ENCLOSURE 5 TO SERIAL: HNP-99-071

SHEARON HARRIS NUCLEAR POWER PLANT
NRC DOCKET NO. 50-400/LICENSE NO. NPF-63
REQUEST FOR LICENSE AMENDMENT
TECHNICAL SPECIFICATION TS 3/4.2.2, TS 3/4.2.3, TS 3/4.2.5

TECHNICAL SPECIFICATION PAGES

Figure 3.2-3 Deleted Add

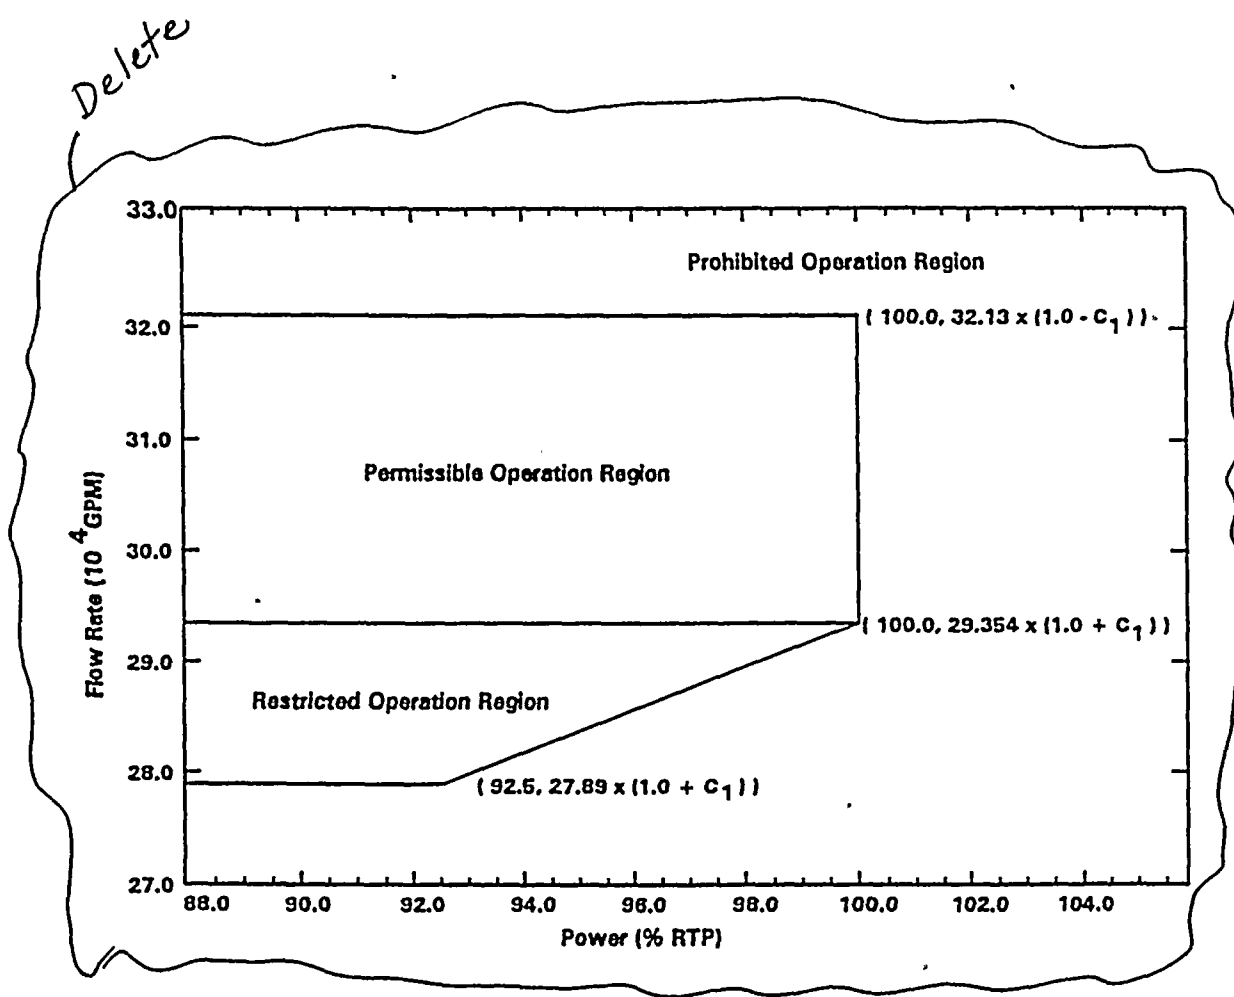
4.2.3.3 The RCS total flow rate shall be verified to be within the regions of restricted or permissible operation of Figure 3.2-3:

Delete Allowed Measured Reactor Coolant System Total Flow Rate versus Power - Three Loops in Operation

$F_{\Delta H}$ will be maintained within its limits provided Conditions a. through d. above are maintained. The combination of measured RCS flow rate and THERMAL POWER must be maintained within the regions of permissible or restricted operation as shown in Figure 3.2-3 to ensure that the combination of RCS flow rate and THERMAL POWER are within the ranges considered in the mechanical and safety analyses and, along with the measurement of $F_{\Delta H}$, to ensure that the calculated DNBR will not be below the design DNBR value. The relaxation of $F_{\Delta H}$ as a function of THERMAL POWER when in the region of permissible operation allows changes in the radial power shape for all permissible rod insertion limits.

For the FSAR Chapter 15 analyses reliant on the Power Range ^{approximately} Neutron Flux - High Trip Setting trip function, reduction of the Setpoint by the same percentage as the required power reduction in Figure 3.2-3 (1.5% RTP per 1% RCS flow rate) ensures DNBR margin is maintained. When in the region of restricted operation, defining ΔT_0 as the equivalent ΔT at 100% RTP and $[293,540 \text{ gpm} \times (1.0 + C_1)]$ (which includes measurement uncertainty for core flow) results in an effective OTAT setpoint reduction and maintains DNBR margins for those analyses reliant upon the OTAT trip. The additional restrictions on $F_{\Delta H}$ when in the region of restricted operation ensure that the margins gained by the power and setpoint reductions are not reduced by the normally allowable increases in radial peaking at reduced power levels.

Figure 3.2-3 Deleted
